Application No.	Applicant(s)
Notice of Allowability	10/582,188	MATSUSHITA ET AL.
	Examiner	Art Unit
	Tu T. Nguyen	2886
The MAILING DATE of this communication appears on the cover sheet with the correspondence address		
All claims being allowable, PROSECUTION ON THE MERITS IS (OR REMAINS) CLOSED in this application. If not included herewith (or previously mailed), a Notice of Allowance (PTOL-85) or other appropriate communication will be mailed in due course. THIS NOTICE OF ALLOWABILITY IS NOT A GRANT OF PATENT RIGHTS. This application is subject to withdrawal from issue at the initiative of the Office or upon petition by the applicant. See 37 CFR 1.313 and MPEP 1308.

Application/Control Number: 10/582,188

[Fig. 3]

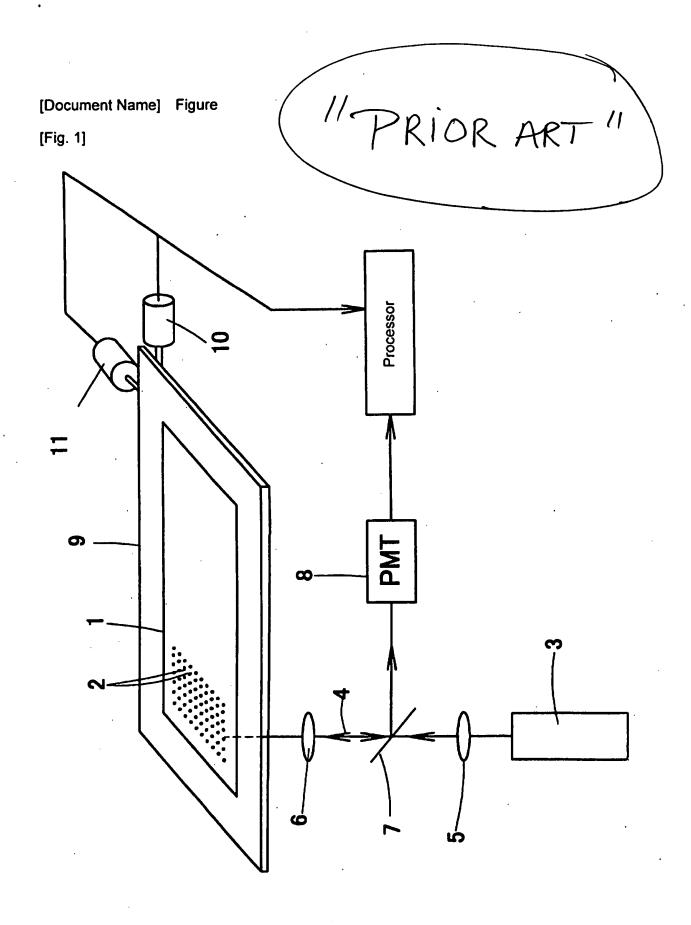
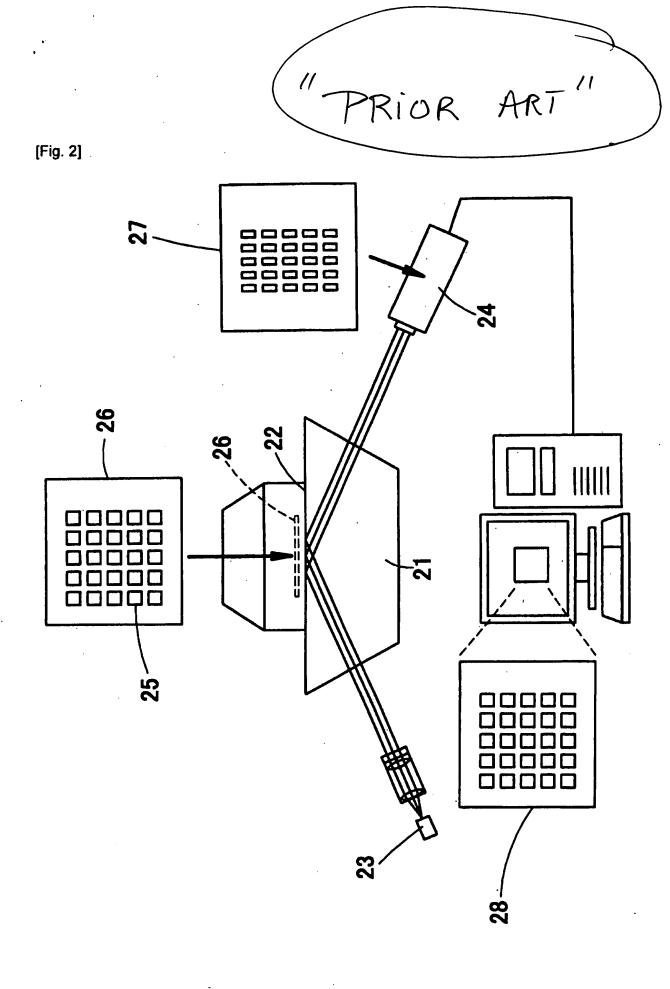
Figures <u>1-3</u> should be designated by a legend such as --Prior Art-- because only that which is old is illustrated. See MPEP § 608.02(g). Corrected drawings in compliance with 37 CFR 1.121(d) are required in reply to the Office action to avoid abandonment of the application. The replacement sheet(s) should be labeled "Replacement Sheet" in the page header (as per 37 CFR 1.84(c)) so as not to obstruct any portion of the drawing figures. If the changes are not accepted by the examiner, the applicant will be notified and informed of any required corrective action in the next Office action. The objection to the drawings will not be held in abeyance.
